FILE P. I. No. 142285-, Gwinnett County **OFFICE** Preconstruction
BRST0-0998-00(001)
SR 324 Gravel Springs Road @ I-85 **DATE** June 30, 2008

SUBJECT APPROVED REVISED PROJECT CONCEPT REPORT

SUBJECT Revised Project Concept Report

REVISED PROJECT CONCEPT REPORT

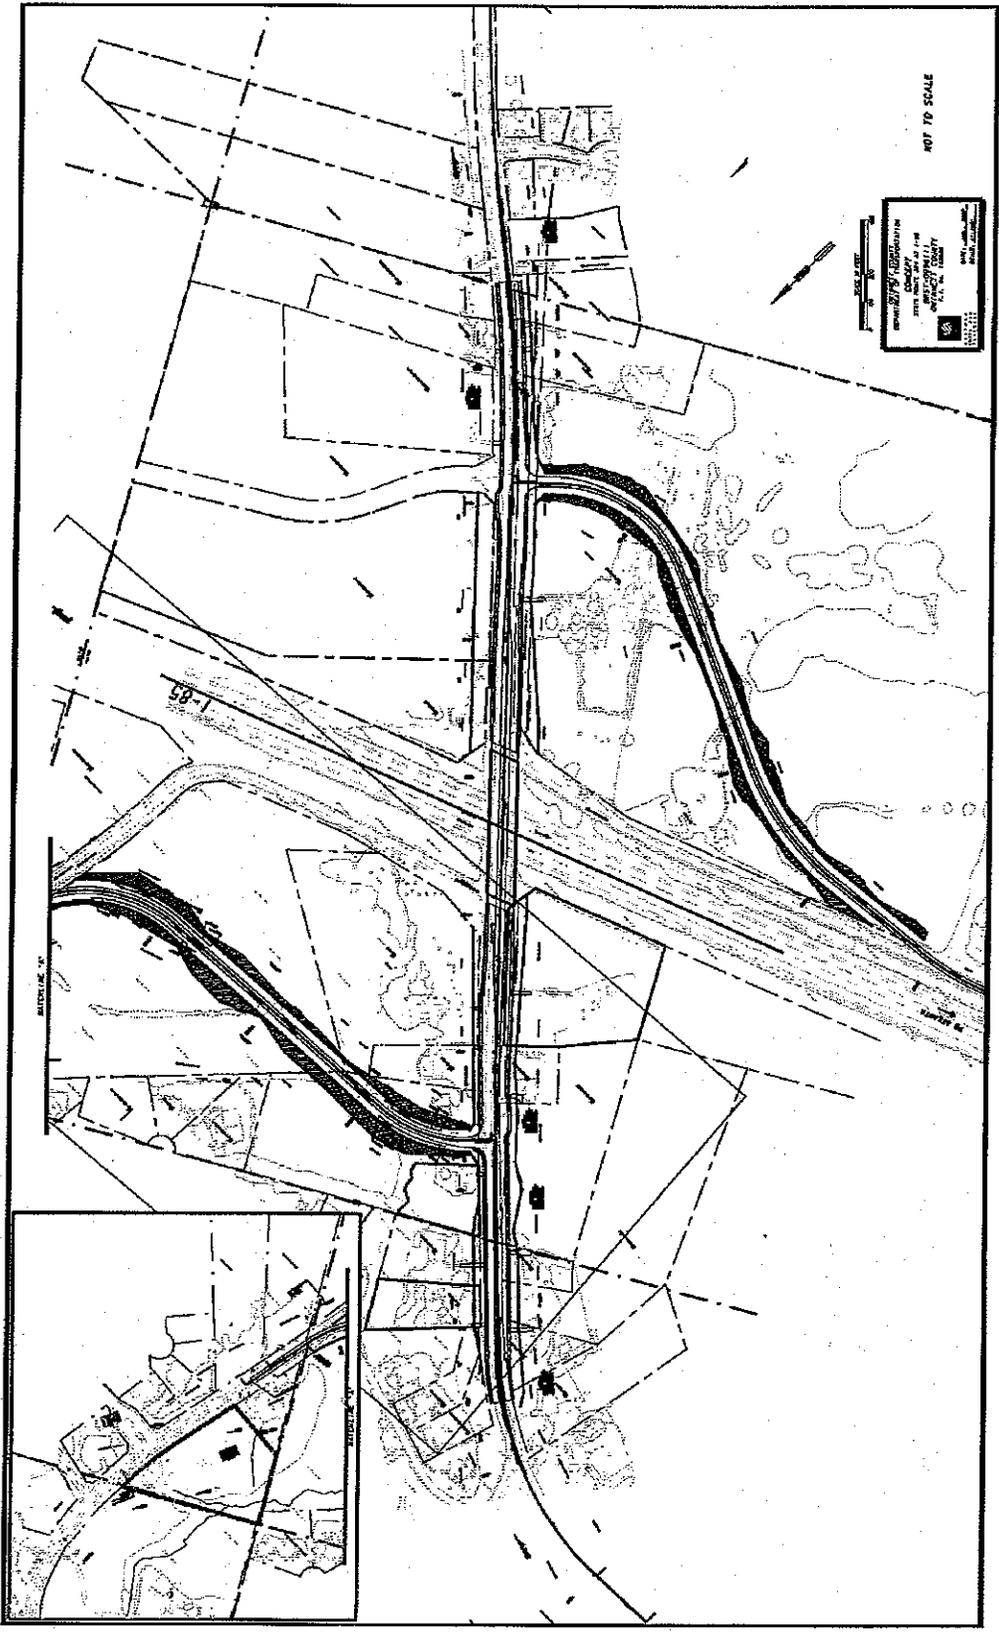
The typical section and the alignment have been revised. The project termini, access control and controlling criteria have not changed. The Typical Section has been revised to include 2-12 ft. travel lanes northbound, 2-12 ft. travel lanes southbound, curb and gutter with a 36 ft. median and 6' sidewalks on each side. The 36 ft. median will transition to a 24 ft. median prior to the Camp Branch Road and Morgan Road intersections. The 36' median will provide for enhanced safety and not preclude providing for three future left-turn lanes on the bridge; one continuous turn lane in each direction on the full bridge length, and one left turn lane transitioning between northbound and southbound.

The bridge on S.R. 324 over I-85 will also be revised now to one bridge structure 102'-5" in width and 466' in length, eliminating the retaining walls and HOV box section. HOV access is planned for another location and therefore consideration for this has been removed from the project. The bents on the three span bridge will be located between the future collector-distributor lanes and the travel lanes on I-85. No changes to the horizontal alignment on I-85 will be required.
